REVISED AGENDA
SOUTHERN CORRIDOR REVIEW BOARD
Wednesday, June 5, 2013
3:00 P.M.

MEMORANDUM

RE: Parker's Convenience Store, COFA-4-13-5617

MEETING DATE:	May 8, 2013
PROJECT:	Parker's Convenience Store – Certificate of Appropriateness – Highway Corridor Overlay
PROJECT MANAGER:	Erin Schumacher, Senior Planner

Landscape Plan
Scale: 1" = 20'-0"

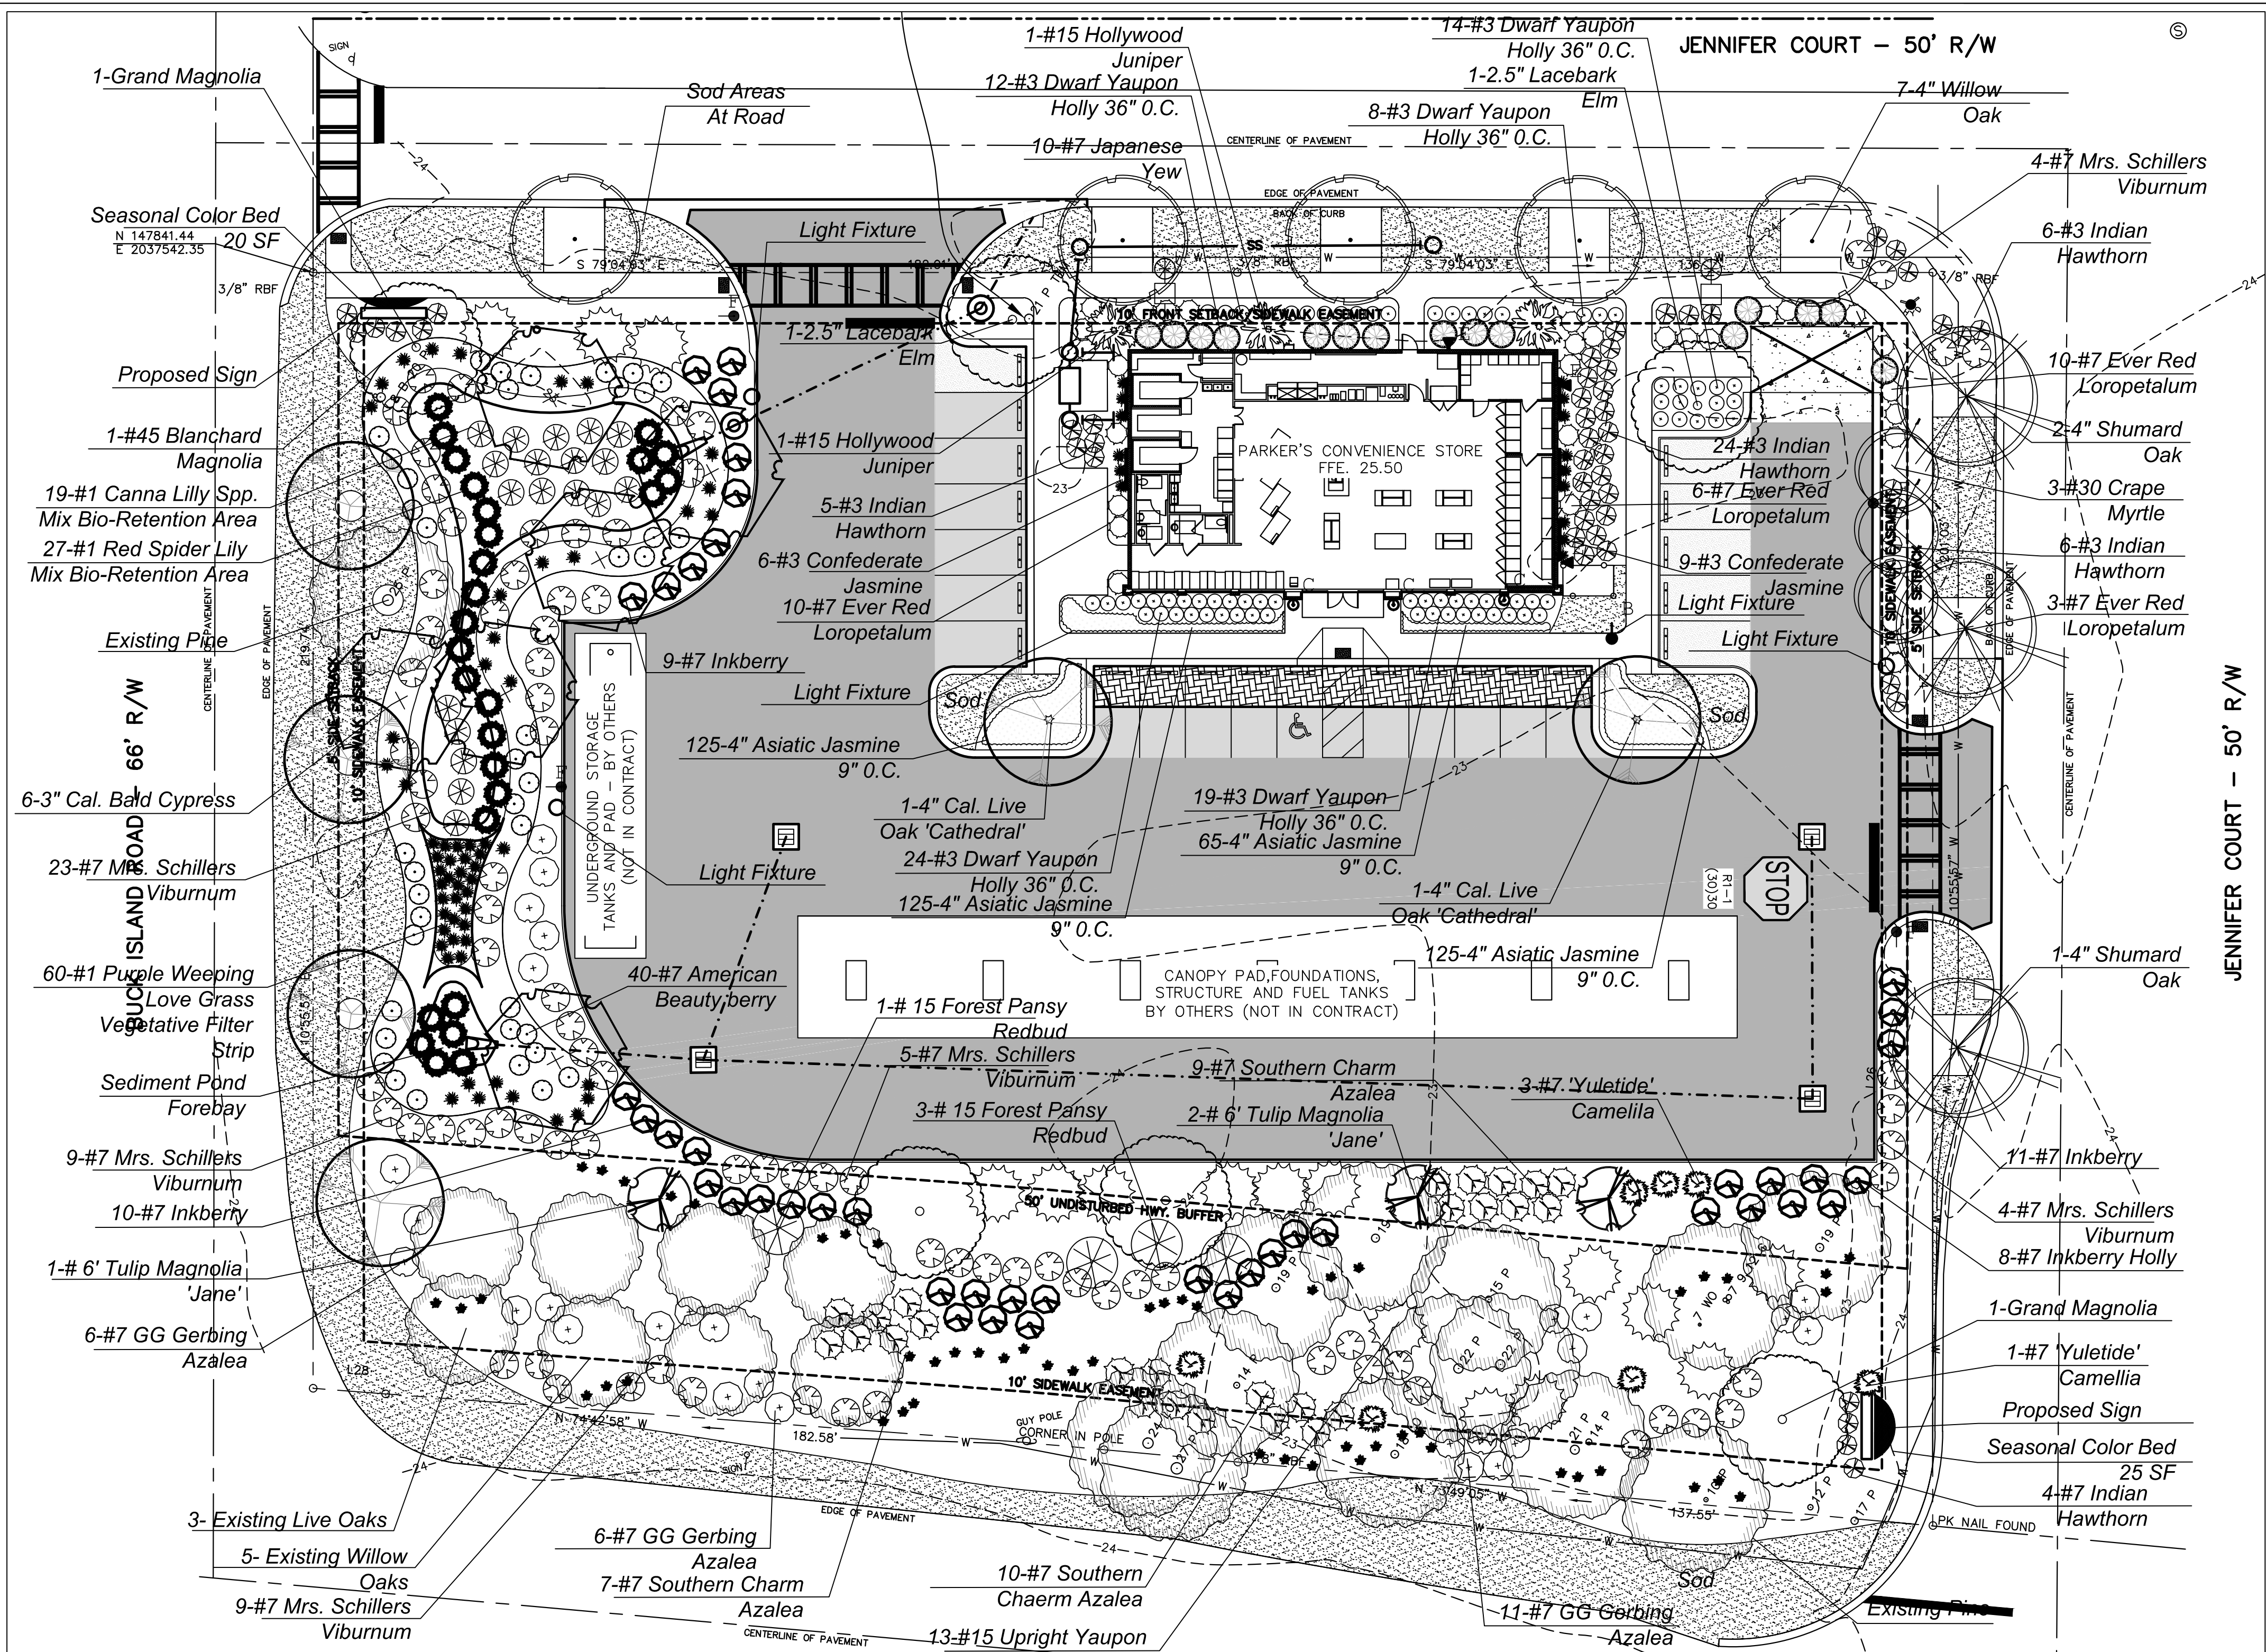
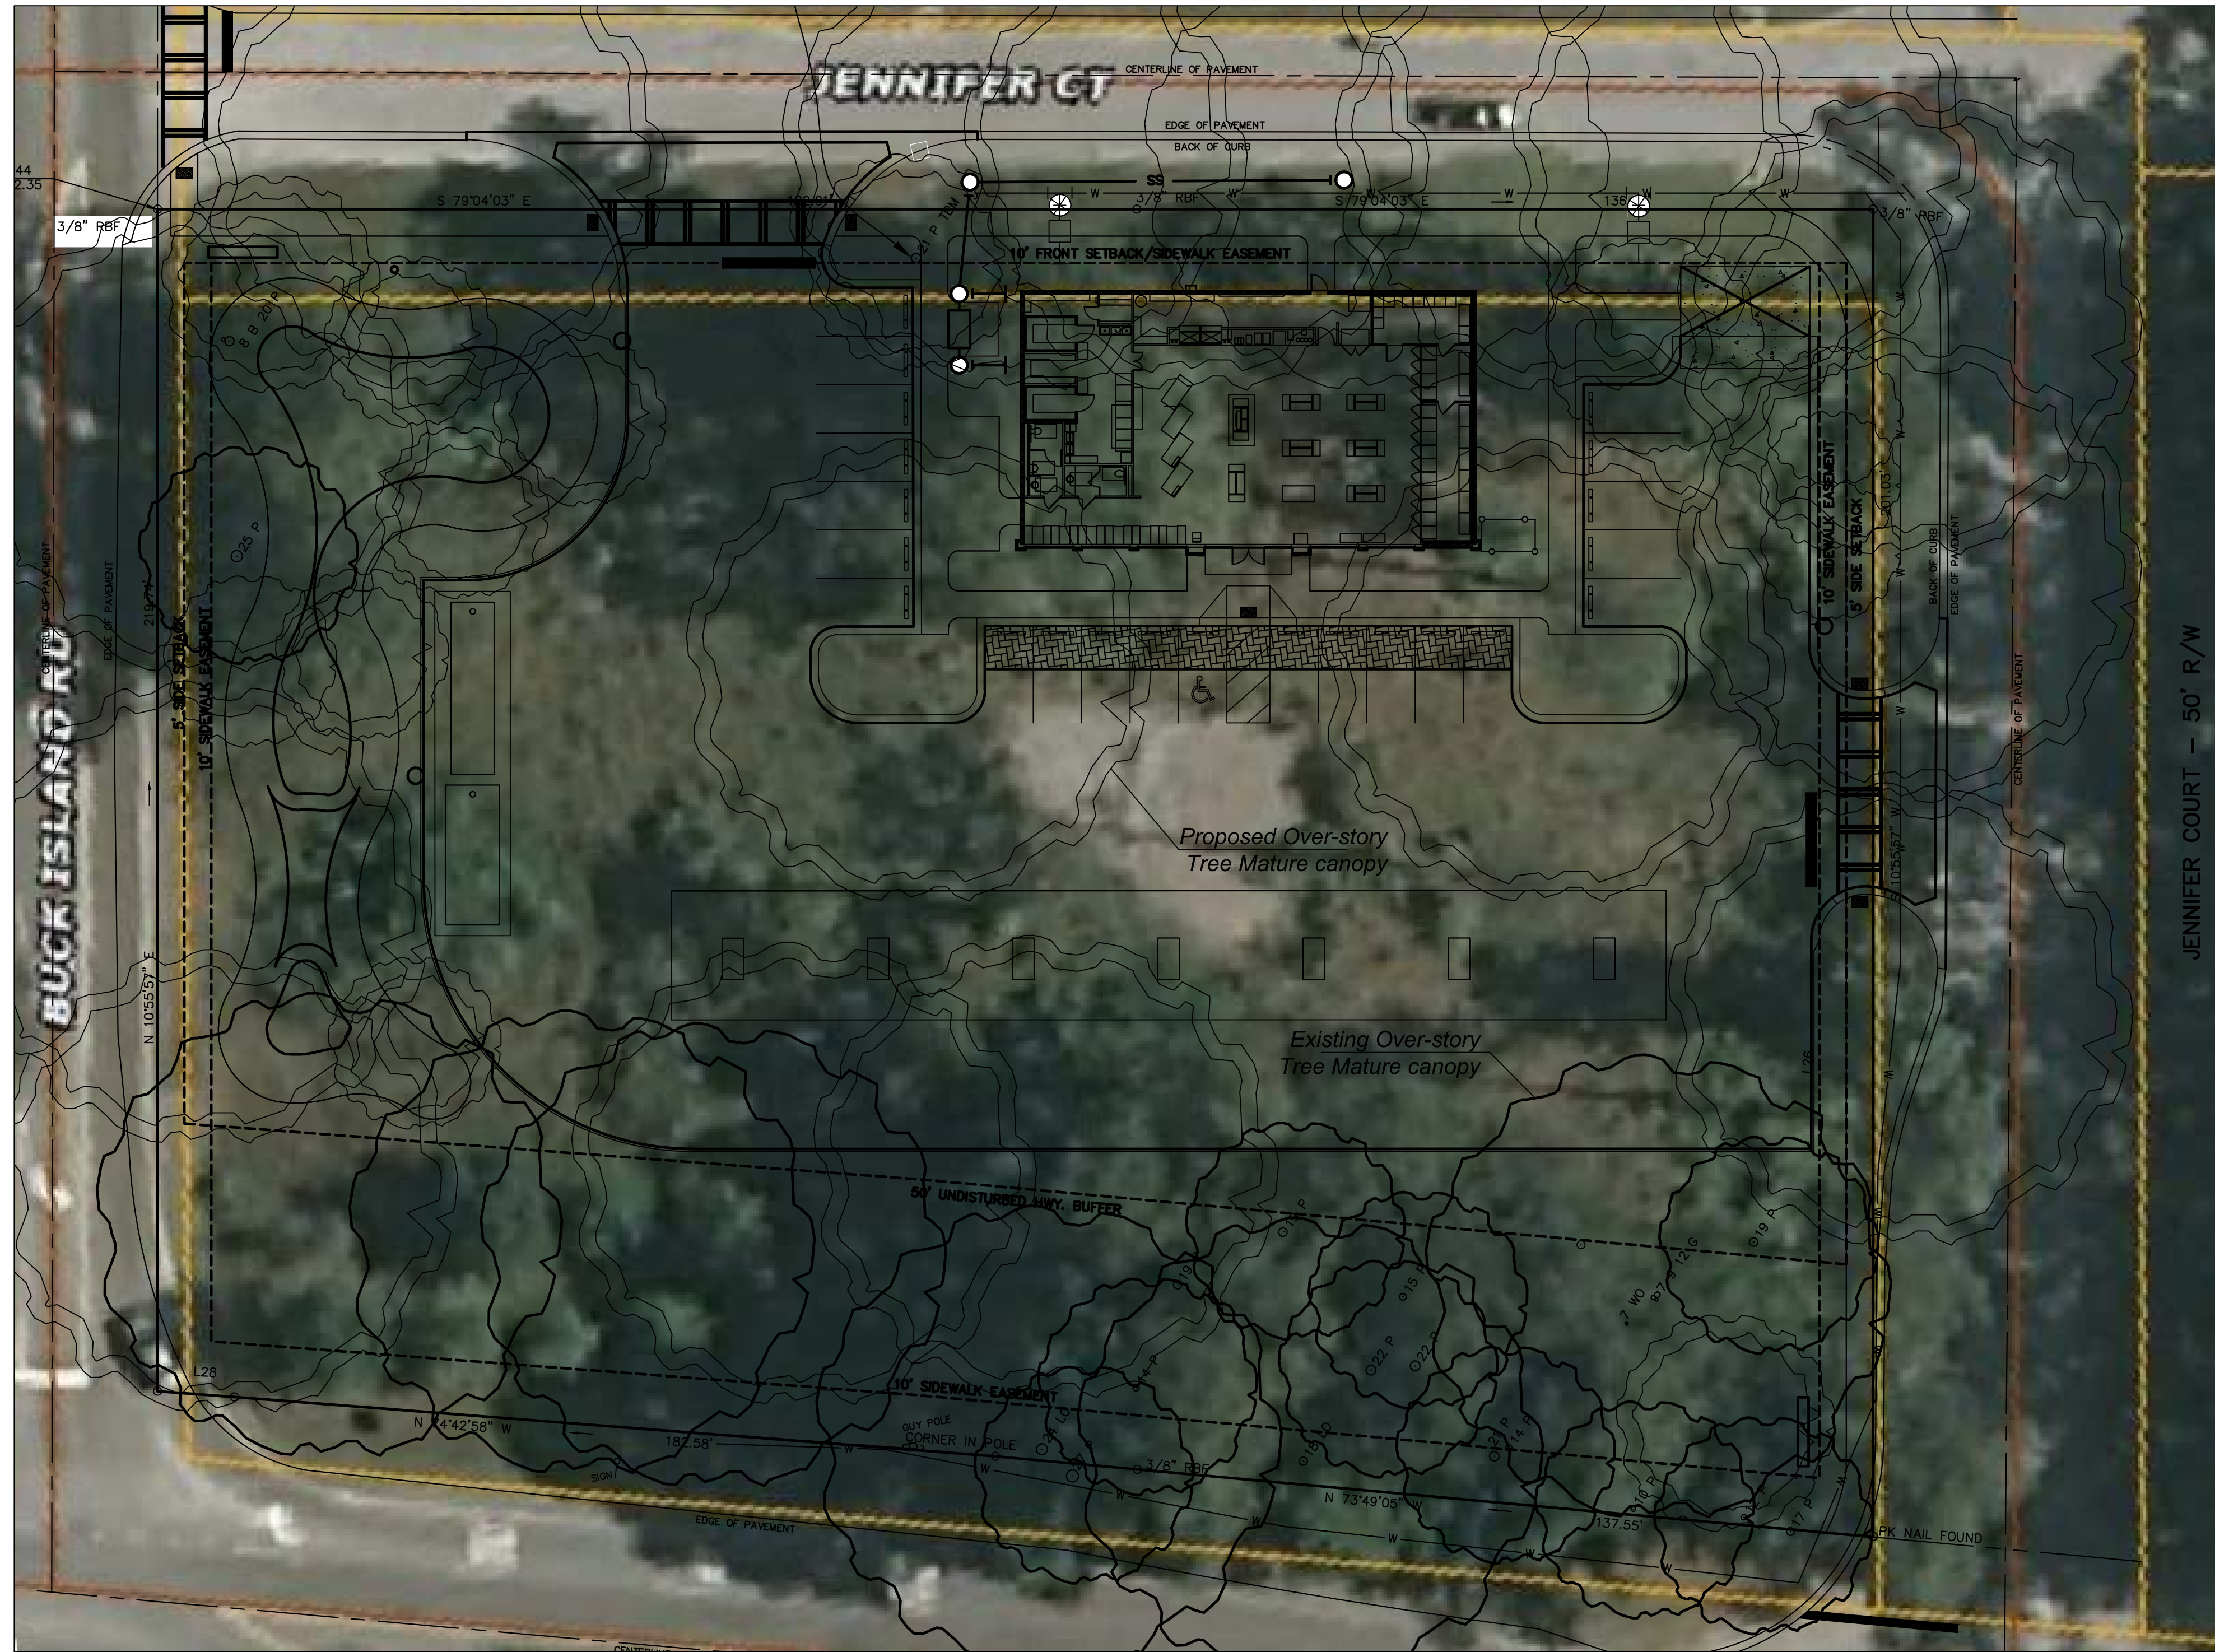
1. **Landscaping.** Section 5.3 of the Unified Development Ordinance (UDO) prescribes requirements regarding landscaping that must be met to be in accordance with the review criteria. While significant changes were made to the plan to accommodate the previous comments Town Staff finds that the revised Landscape Plan still does not fully meet the requirements prescribed in Section 5.3 of the UDO.
 - a. Per Section 5.3.4.H, submit a revised landscape plan to Town Staff for approval showing that no more than 15% of plant material is of the same species. Specifically, the Watler's Viburnum and Dwarf Youpon Holly shown on the current

landscape plan exceed the 15% standard. Town Staff requires a reduction in quantity of certain species from the Landscape Plan that exceed the allowable percentage and suggest replacement with species consistent with typical landscaping of the May River Scenic Byway.

- B. Section 5.3.4.H. Diversity of species. The UDO requires that no more than 15 percent of plant material shall be of the same species. As proposed on the current landscape plan, Dwarf Yaupon Holly comprises 21 percent of the shrub plant material and Walter's Viburnum 'MSD' comprises 20 percent. For hardwoods, the Red Buds compose 27 percent, the Cathedral Oaks make up 36 percent, and the Bald Cypress comprises of 16 percent of the plant material. The amount used of these species

- a. Per Section 5.3.4.H, submit a revised landscape plan to Town Staff for approval showing that no more than 15% of plant material is of the same species. For example, the Red Bud and Willow Oak species shown on the current landscape plan exceed the 15% standard. Town Staff will require the reduction in quantity of certain species from the Landscape Plan to achieve compliance and further recommend the Applicant maximize the variety and quantity of Oak and Magnolia species consistent with typical landscaping of the May River Scenic Byway.

1. Per Section 5.3.4.H, the Applicant must submit a revised landscape plan for Town Staff approval showing that no more than 15% of plant material is of the same species. Town Staff will require the reduction in quantity of certain species from the Landscape Plan to achieve compliance and further recommend the Applicant maximize the variety and quantity of Oak and Magnolia species consistent with typical landscaping of the May River Scenic Byway.
2. The Applicant is strongly encouraged to install Lighting Plan Option A, which utilizes the Lifestyle CCS fixture matching that of the May River Road Streetscape.
